Executive Order G-70-23-B

Relating to the Modification of the Certification of the
Exxon Balance
Phase II Vapor Recovery System

Executive Order G-70-23-AB

Exxon Balance Phase II
Vapor Recovery System

Exhibit 1

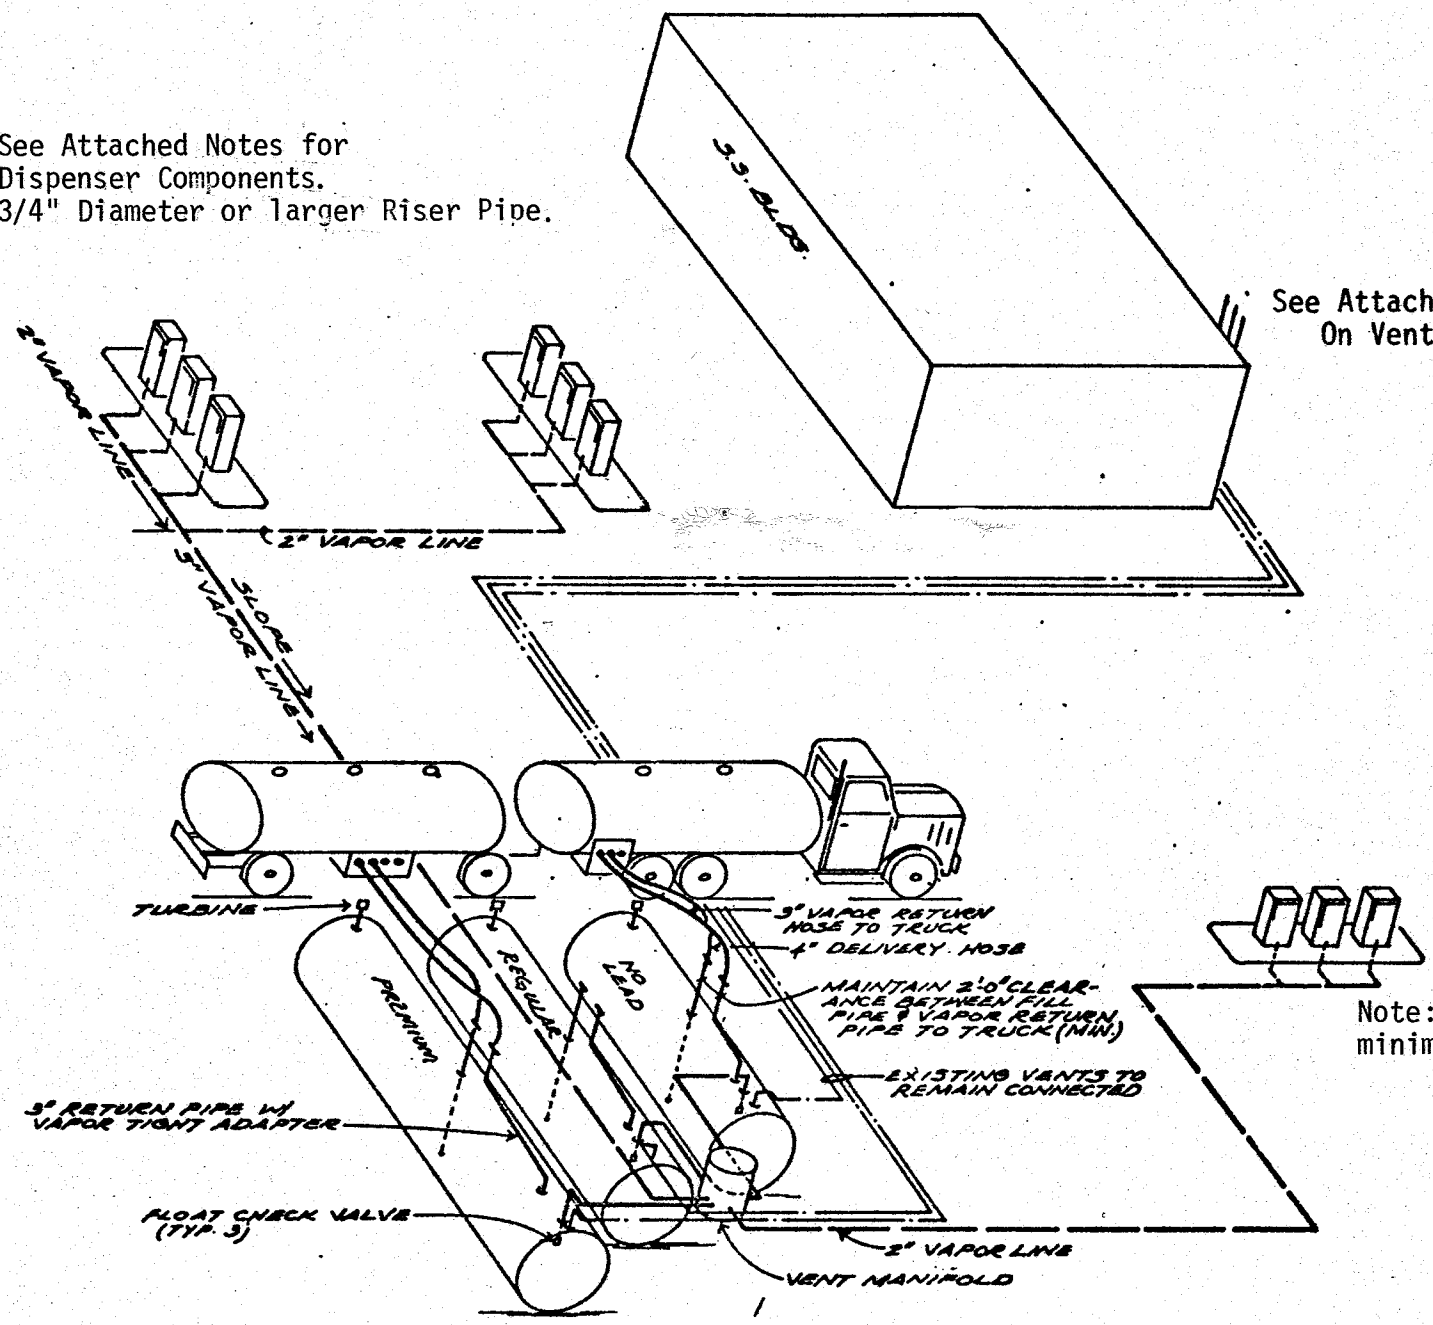
IT IS ORDERED AND RESOLVED: That the certification Executive Order G-70-23-A issued on December 6, 1978, for the Exxon balance Phase II vapor collection and disposal system is hereby modified to eliminate the previously allowed use of a single OPW 78 series recirculation trap on dual dispensers dispensing the same product from both sides. The system hereby modified is certified to be at least 95% effective in self-serve and/or attendant use at gasoline service stations in conjunction with Phase I vapor recovery system which have been certified by the Air Resources Board. The system is described in Exhibits 1 and 2, attached hereto.

~~10. On dual dispensers dispensing the same product from both sides, the vapor return lines may be connected to a single OPW 78 series recirculation trap.~~

See Attached Notes for
Dispenser Components.
3/4" Diameter or larger Riser Pipe.

See Attached Notes
On Vent Pipes

Note: pipe sizes are
minimum requirements
